**Bulletin**

MODEL BENTLEY MARK VI

EXCESSIVE LEAKAGE OF OIL AT THE CENTRE STEERINGLEVER AND STUB AXLES(CENTRALISED CHASSIS LUBRICATION SYSTEM).FOR INFORMATION:

Fig. 1. Section through ball joint at front end of side steering tube.

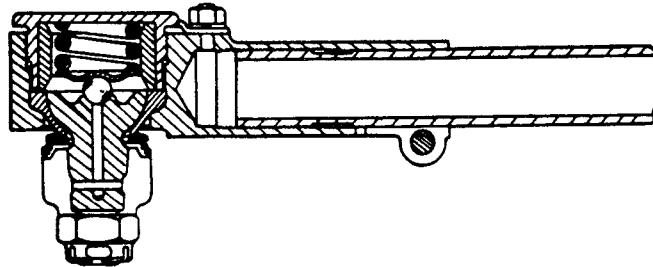
When the pedal of the chassis oil pump is operated, a relatively large quantity of air is trapped in the three ball joints connected to the centre steering lever and compressed. During the next few hours, the trapped air expands, pushing the oil along until it escapes past the fulcrum pin bearings of the centre steering lever pivot assembly and the bearings of the stub axles.

The cure lies in packing the four joints of the cross steering tubes and the ball joint at the front end of the side steering tube with a soft type of grease such as Duckham's HBB grease in order to displace the air.

- (i ) Remove the front right-hand undershield. Jack up front wheels and turn wheels to full right-hand lock.
- (ii ) Remove split pin and nut from ball pin.
- (iii) Place a substantial steady block in contact with the lever near the ball pin to be removed, in order to provide a solid re-action point, and then with the aid of a large steel drift and hammer, give the eye of the lever (adjacent to the ball pin) one or more sharp blows which will release the tapered shank of the pin from its location in the lever. NOTE: The above method applies to all the ball joints to be removed.
- (iv ) Collect the pressure spring and the sealing disc.
- (v ) Remove the cap nut of the joint (see Fig.1) and completely pack the joint with grease.

- (vi) Before refitting the ball joint (ball pin) to the lever, clean the tapered shank of the pin and corresponding hole. With the sealing disc and pressure spring in position on the pin and the correct way round (See Fig. 1), refit the ball pin to the lever, fully tighten up the nut and secure with a new split pin of the correct size.

Fig. 2. Section through a ball joint (outer) of a cross steering tube.

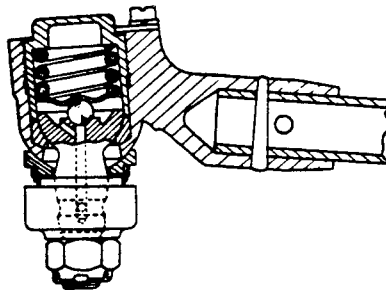
NOTE: Do not use a hammer when refitting the ball pin to the lever, but rely on tightening the nut to draw the mating parts together. Treat the four ball joints of the cross steering tubes in a similar manner. Fig. 2 shows a section through a ball joint (outer) of a cross steering tube. Finally inspect that no split pins, locking plates and spring washers have been omitted.

FIG. 1.

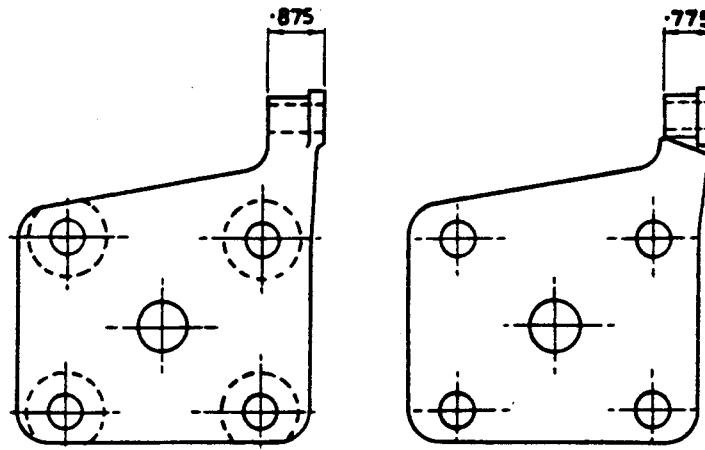
Retailers are advised that a new type of strengthened rear spring plate for the shock damper linkage attachment has been introduced on current models in production. This supersedes the earlier designs fitted and is now the only replacement available.

The new plate (Fig.1) is similar in general shape to the earlier designs, but no machining has been carried out on either face beyond the spot facing on the underside of the 'U' bolt holes. Owing to this, left-hand and right-hand plates are now required as follows:-

An intermediate type of modified spring plate, RF-8101 (Fig.2) was used for a short period prior to the introduction of the latest design, but this has proved unsatisfactory in service. In view of this, it has been decided to request Retailers to modify all cars in their areas fitted with this intermediate type plate on a Category 1 basis.

It should be noted, that due to the increased width of the boss on the new type plate (0.875" as against 0.775" on the earlier design) new anchorage pins for the lower shock damper linkage will also be required when these new plates are fitted. These pins are supplied separately, and should be assembled in their respective plates prior to these being fitted to the car.

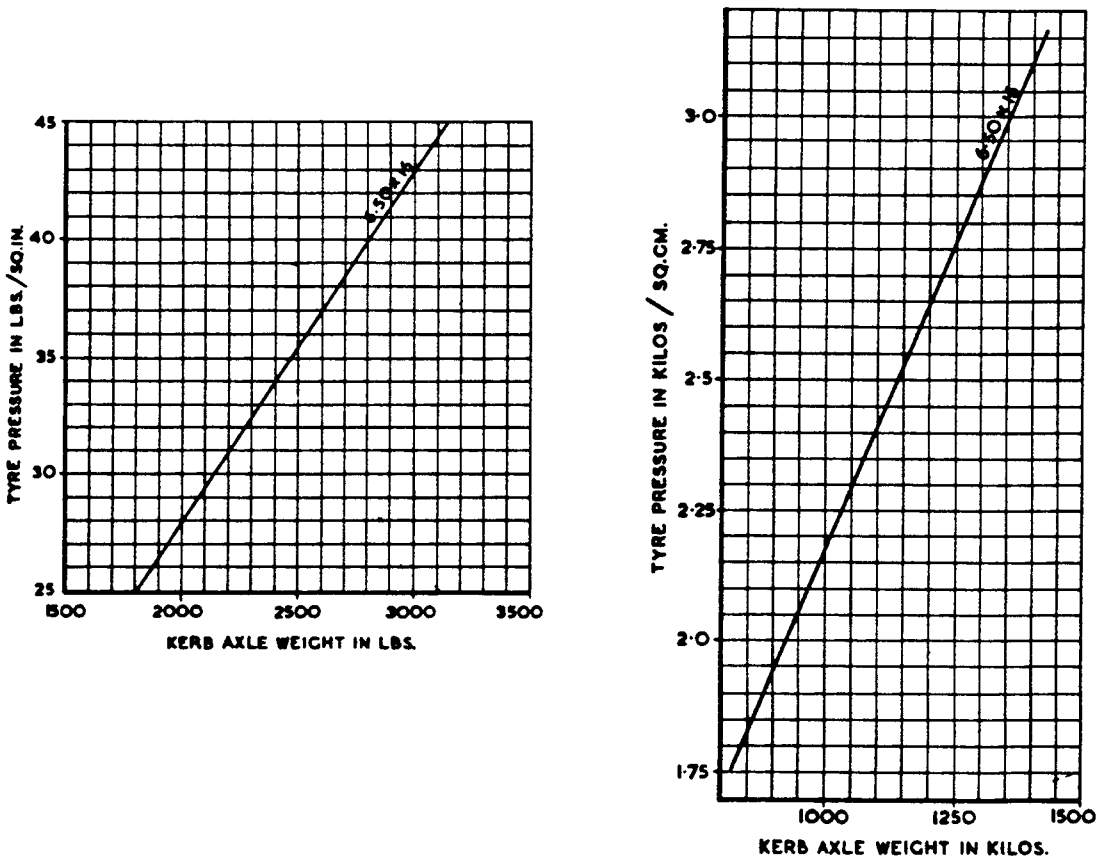
The weight on the front wheels is unlikely to vary sufficiently to warrant any alteration in the recommended front tyre pressures, but the rear axle weight on certain cars may necessitate an increase in the rear tyre pressures.

The following chart shows the recommended rear tyre pressures for a given unladen rear axle weight. (This weight is the kerbside weight, i.e. full tank but no passengers).

FIG.1. SECTION - BALL JOINT-SIDE STEERING TUBE REAR END.

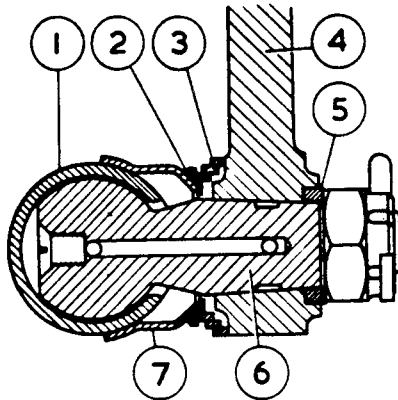
NOTE: When re-connecting the side steering tube to the pendulum lever, it is important that the mud excluder (7 Fig.1) is placed the correct way round, i.e. with the longest plain portion pointing

towards the rear end of the tube. After placing the ball pin in the pendulum lever, make sure that the flats and lugs of the locating washer (5 Fig.1) correctly engage with the corresponding flats and slots on the ball pin and in the lever.

If it was found necessary to remove the slotted end-nut, rear ball pad and the spring and guide assembly from the rear end of the side steering tube then prior to placing the ball pin in the pendulum lever measure the length of the coil spring and if it has a free length of 0.875" (22.2 m/m) the adjustment of the rear end of the side steering tube is as follows:-

Screw in the slotted end-nut, until the ball pads, spring and guide assemblies are choc-a-bloc. Slacken the end-nut back 0.100" (2.5 m/m) in order to restore the original working clearance of 0.050" (1.27 m/m) between the end of each stem of the ball pads, and the inner end of the tube and the inner face of the end-nut. In all cases the end-nut must be secured by a new split pin. Part No. K.4616/Z.

FIG.3. SECTION-SOCKET-SIDE STEERING TUBE FRONT END  
(AFTER MODIFICATION.)

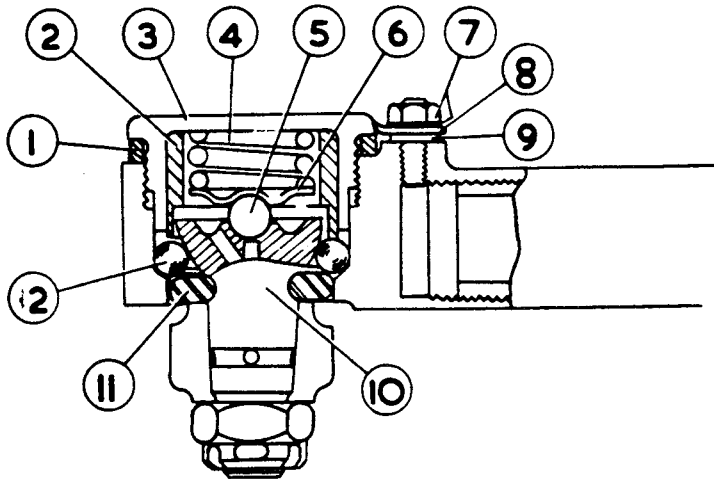
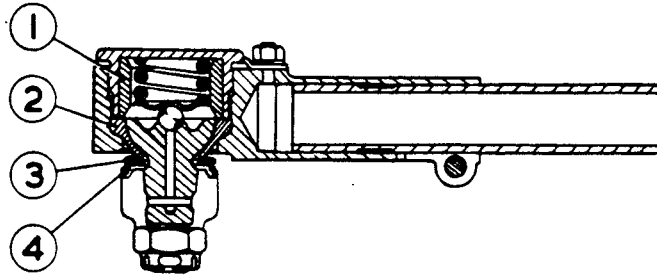
Commencing at Chassis No.B-215-PU steel balls (12 Fig.2) were incorporated in place of the previous bronze seat (2 Fig.3) in the front end socket of the side steering tube to reduce steering friction.

Owing to the steel balls grooving and causing hard steering, these have been discarded and reversion has been made to the original bronze seat as from Chassis No.B-390-TN and onwards on right-hand and left-hand drive cars.

This modification is therefore introduced to modify Chassis Nos.B-215-PU to B-388-TN (inclusive) to revert to the previous arrangement.

- (i) Remove the rubber seal (11 Fig.2) from the groove in the ball pin.
- (ii) Remove the nut and spring washer, (7), the locking plate (8), the plain washer (9), and with a 'C' spanner, remove the cap nut (3).
- (iii) Remove the joint ring (1) from the cap nut, the sleeve (2), the spring (4), the spring pad (6), the ball (5), the ball pin (10), and finally the steel balls (12). Items 1, 2, 9, 11 and 12, should be discarded. The sleeve (2) is replaced by the sleeve RF-3561. Clean the remaining dismantled parts.
- (iv) Re-assemble the ball joint, using the new parts as illustrated in Fig.3, and refit to the centre steering lever.

NOTE: When it is found that the ball end pin (10 Fig.2) of the front socket has been grooved or pitted by the steel balls, a new pin FW-1000 (included in the list of parts on Page 1) should be fitted.
